Project Description: Antioch Apartments

Project/File: **Antioch Apartments/ GC25-0008/ DSRFY2025-0008**

This is a design review application to allow for the development of 236 apartments within two 4-story buildings on 16-acres. ACHD is a recommending body to Garden City for this type of application.

C. Site Plans

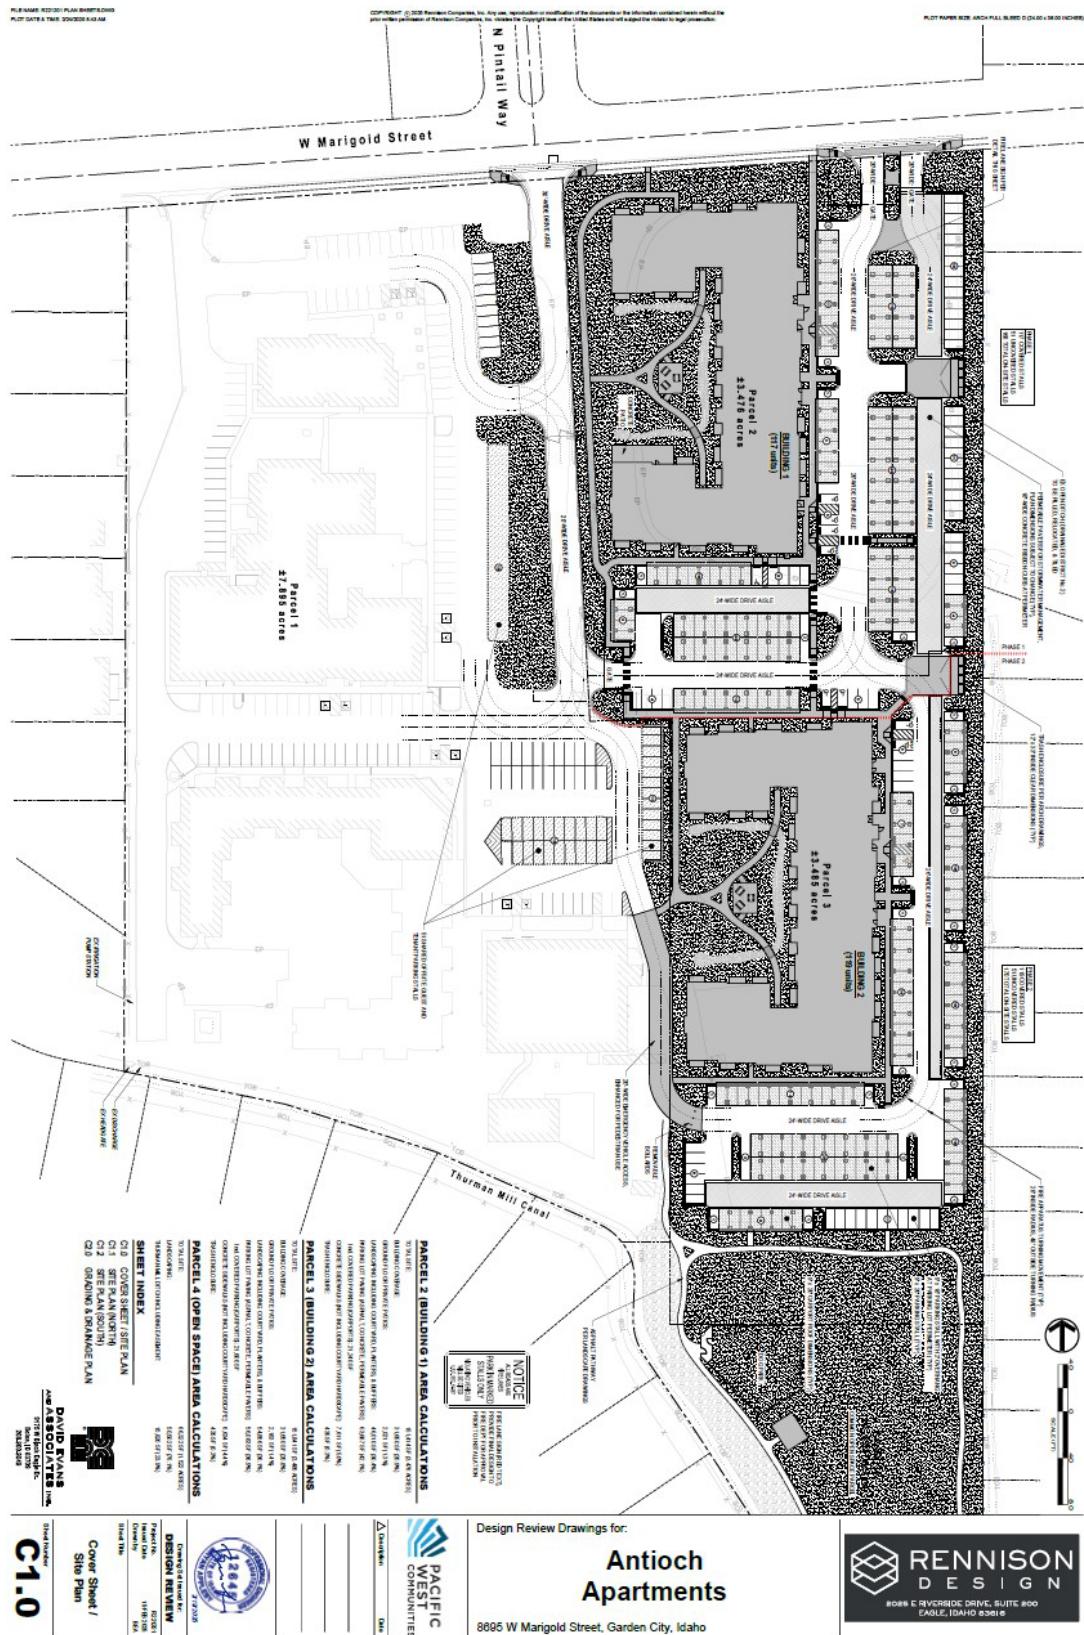
The applicant is proposing to construct a curb return type driveway from the site onto Marigold Street located 298-feet east of Pintail Way with two 20-foot wide travel lanes and two 12-foot wide center landscape island. The applicant is proposing to provide a turnaround and a gate for this driveway located 50-feet from the near edge of pavement of Marigold Street.

The applicant's proposal to construct a third driveway onto Marigold Road for this site does not meet District Access Management and Driveway Width policies which limits and controls access to collector roadways and restrict driveways to a maximum width of 36-feet and should not be approved as proposed. Because the site has two existing driveways, the applicant should be required to utilize those driveways to provide access to the proposed development.

2. Utilize the two existing curb return type driveways onto Marigold Street to provide access to the proposed development, located as follows:
 - 28-foot wide driveway located 203-feet east of Ensign Avenue

- 30-foot wide driveway located in alignment with Pintail Way on the north side of Marigold Street across from the site.
3. Submit civil plans to ACHD Development Services for review and approval. The impact fee assessment will not be released until the civil plans are approved by ACHD.
